CADILLAC OF NOVI JSP 25-07

Public Hearing at the request of Cadillac of Novi for Planning Commission's recommendation to City Council to consider a Preliminary Site Plan with an amended Special Development Option Concept Plan, Section 9 Façade Waiver, and Stormwater Management Plan in the GE, Gateway East district. The subject property totals 6.77 acres and is located on the northeast corner of Grand River Avenue and Meadowbrook Road (Section 24). The applicant is proposing to build a 4,174 square foot building addition, expand the parking lot, update the building façade and signage.

PLAN REVIEW CENTER REPORT

Review Date: July 16, 2025
Review Type: Preliminary Site Plan
Project Name: JSP25-07 Cadillac of Novi
Plan Date: June 23, 2025
Prepared by: Dan Commer, Planner
Contact: E-mail: dcommer@cityofnovi.org Phone: 248.735.5607

4 SOUTH ELEVATION
A1.1 1/8" = 1'-0"

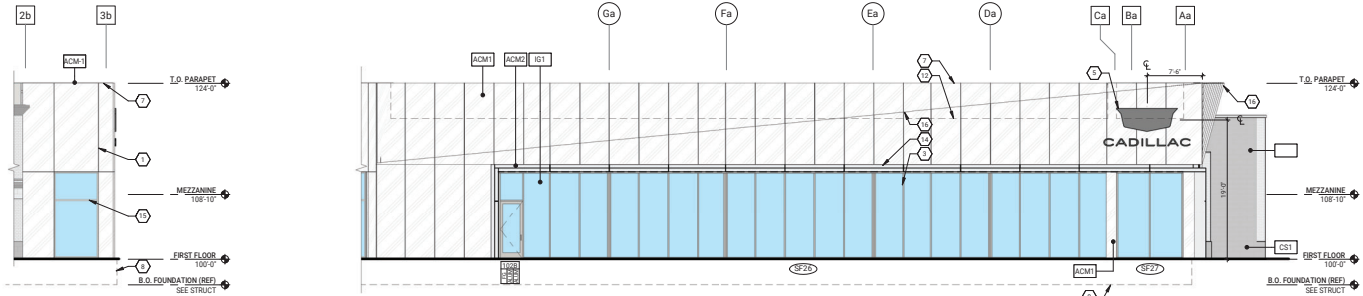
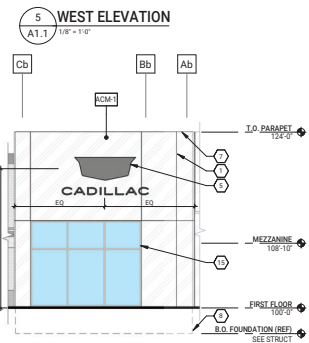
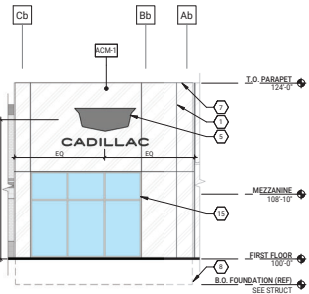
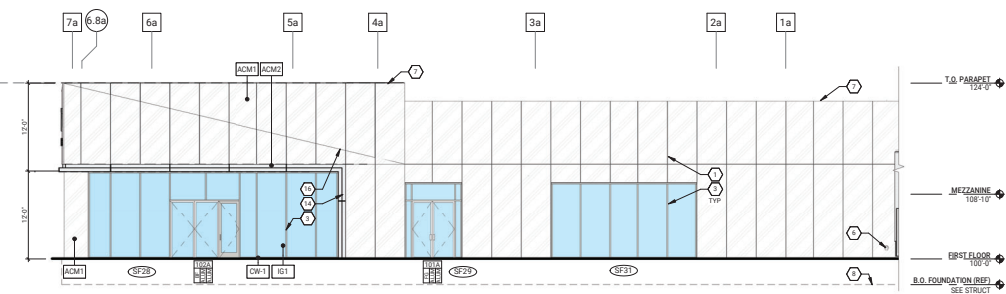
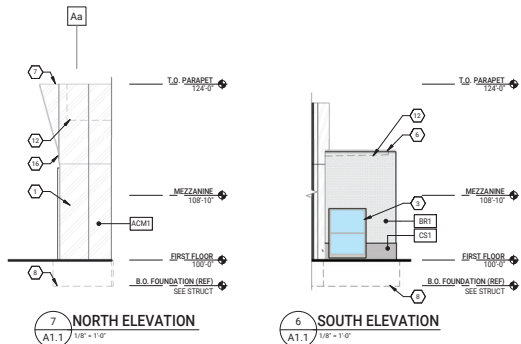
- a. Section 9 Façade waiver for an underage of brick on the South (front) facade of the high-visibility buildings (0% proposed, 30% required), and an overage of Flat Metal Panels on South (front) and East facades (100% proposed (South) and 51% proposed (East), 50% Maximum), *because the angled profile of the Flat Metal Panels will provide an interesting architectural effect that would not otherwise be enhanced by strict application of Façade Ordinance requirements.*

5. Building Façade and Scale (Sec. 3.11.8): Flat Metal Panels (ACM) are proposed for the front of building. A Section 9 Façade Waiver for use of the proposed Flat Metal Panels instead of the required Brick will require approval from City Council as part of a revised SDO agreement and is recommended for approval by the City's Façade Consultant.

Figure 1. City of Novi Regulated Woodlands Map
 Approximate Site boundary is shown in red.
 Approximate Regulated Woodland areas are shown in green.

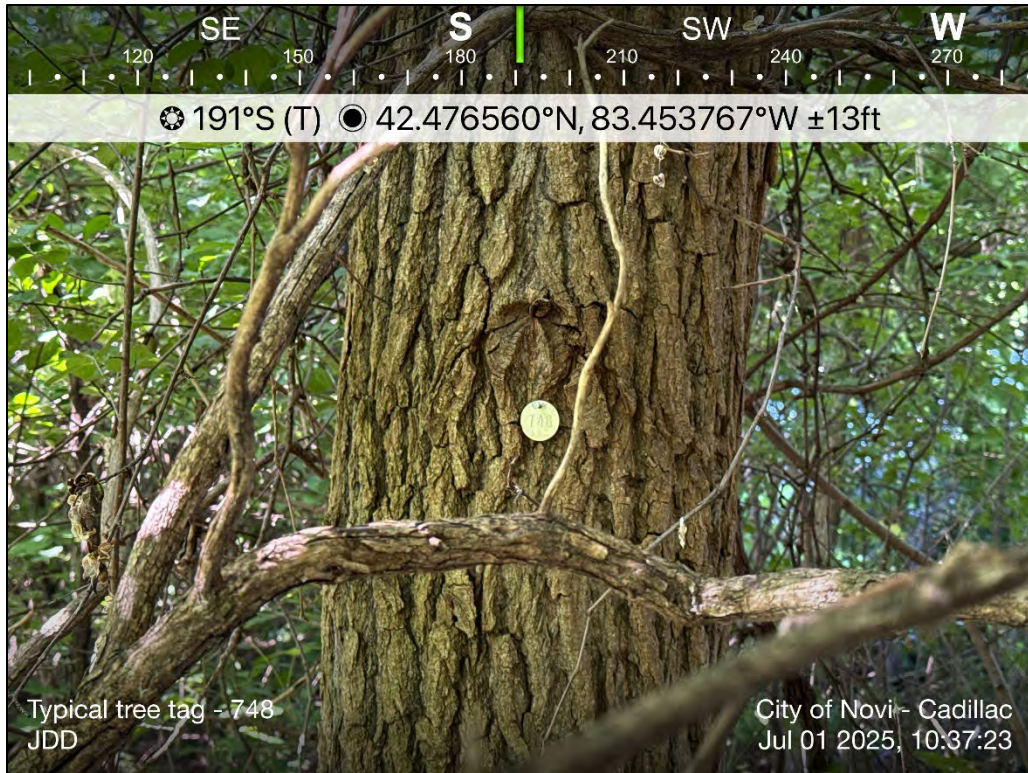
1. City-regulated woodlands, as identified on the City of Novi Woodlands interactive map website, are present onsite. Note that both the woodlands and property limits depicted on the City map are considered approximations (**Figure 1**). Additionally, a wetland and woodland conservation easement is present on-site (map provided in Pre-application Review).
